PCN – Product Change Notification

Document No	PCN-A-090224	Revision	1.0		
--------------------	---------------------	-----------------	-----	--	--

PCN Topic: New 7 inches Open Frame Dimension_ W07T700 -OFA2

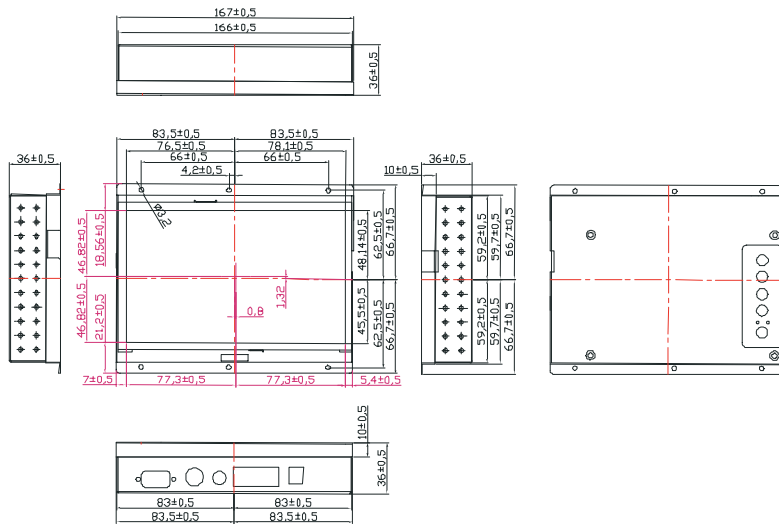
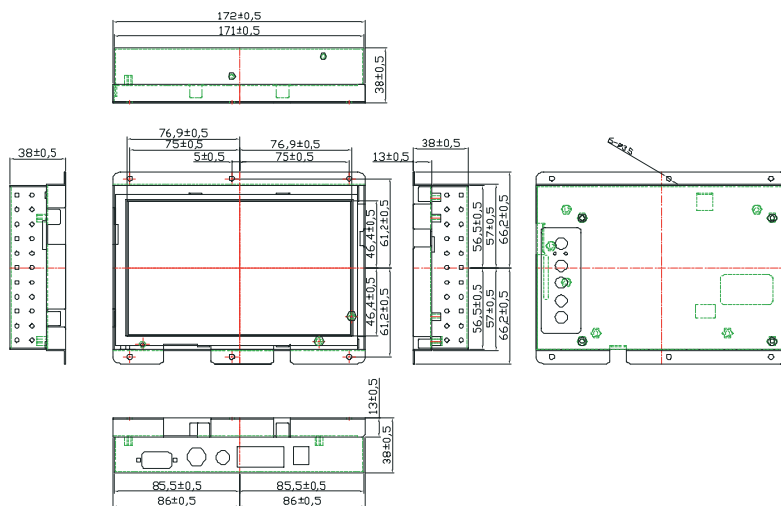
We show the example for the different designs of product with below pictures and the dimension of mechanical will change from 167 x 133.4 x 36 mm to 172 x 132.4 x 38 mm.

Old Mechanical Design:

New Mechanical Dimension:
